Appendix F-4b

**NC's Response to New Jersey's Comments on
NC's Pre-hearing Draft RH SIP**

Subject: Response to Comments on North Carolina's Pre-Hearing Draft Regional Haze State Implementation Plan (SIP) for North Carolina Class I Areas for the Second Planning Period (2019-2028), August 30, 2021

Figure 1. VISTAS Model Performance Evaluation for the Brigantine Wilderness Area in 2011 for 20% Most Impaired Days¹⁹

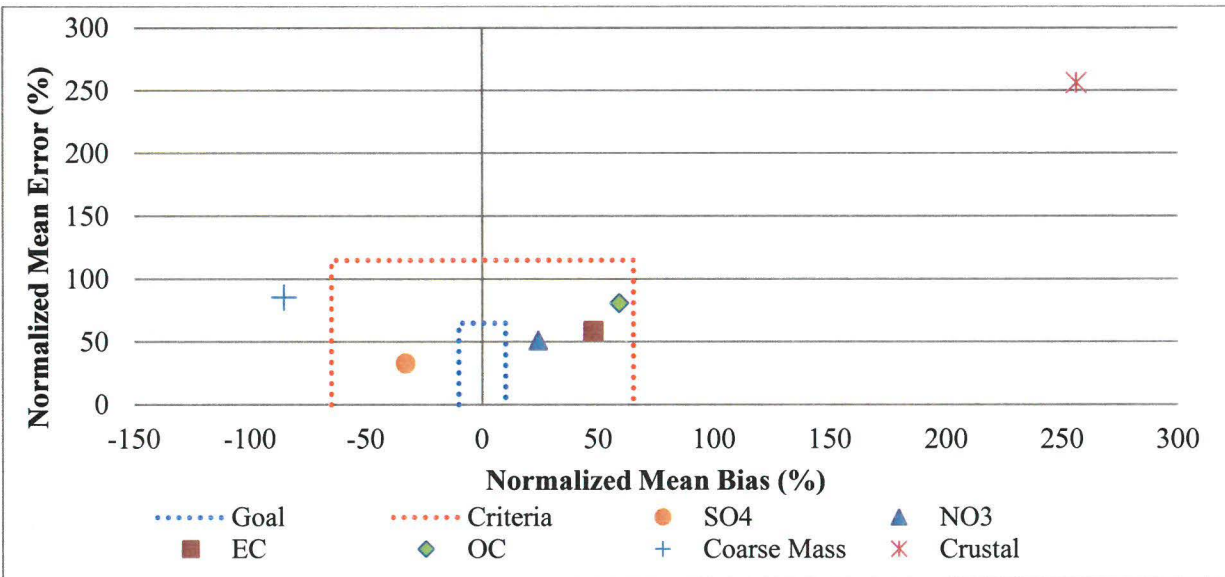
“While CAMx has a robust chemistry, it still struggles in model performance for ammonium nitrate concentrations which is critical to regional haze.”

For the VISTAS project, extensive model performance evaluations were conducted to compare modeled 2011 ozone and particulate matter (PM) species (including nitrate) concentrations, and wet and dry deposition fluxes, to observed concentrations and deposition fluxes collected from 2011 monitoring data including the Interagency Monitoring of Protected Visual Environments (IMPROVE) network. The statistical metrics evaluated suggest satisfactory model performance for regulatory applications. Further, as part of this modeling performance analysis, it was demonstrated that CAMx model performance statistics for nitrates across the VISTAS and non-VISTAS states were within suggested criteria, as given by Emery et al (2017),¹⁶ and similar to EPA's regional haze modeling.¹⁷ In addition, VISTAS used the relative response approach to estimate visibility impairment in 2028 for Class I areas. This approach uses modeled base and future year values and then applies the percentage difference between the two to observed base-year values, thus reducing “...problems posed by imperfect model performance on individual days...”¹⁸ Bias errors in particular are reduced using the relative response approach to estimate PM-species specific future year concentrations.

Figure 1 presents a soccer plot illustrating model performance for the Brigantine Wilderness Area for the 20% most impaired days. The recommended goal performance is defined by the blue dotted line and the recommended criteria performance is defined by the red dotted line. The error is plotted on the y-axis and the bias plotted on the x-axis. The plot is a convenient way to visualize both bias and error model performance on a single plot. As bias and error approach zero, the points are plotted closer to or within the “goal” represented by the dashed boxes. The size of the goal is developed from historical values of the metric for each variable from comparable modeling studies. The results illustrate that nitrates (denoted by the blue triangle) were well within recommended normalized mean bias and normalized mean error criteria.
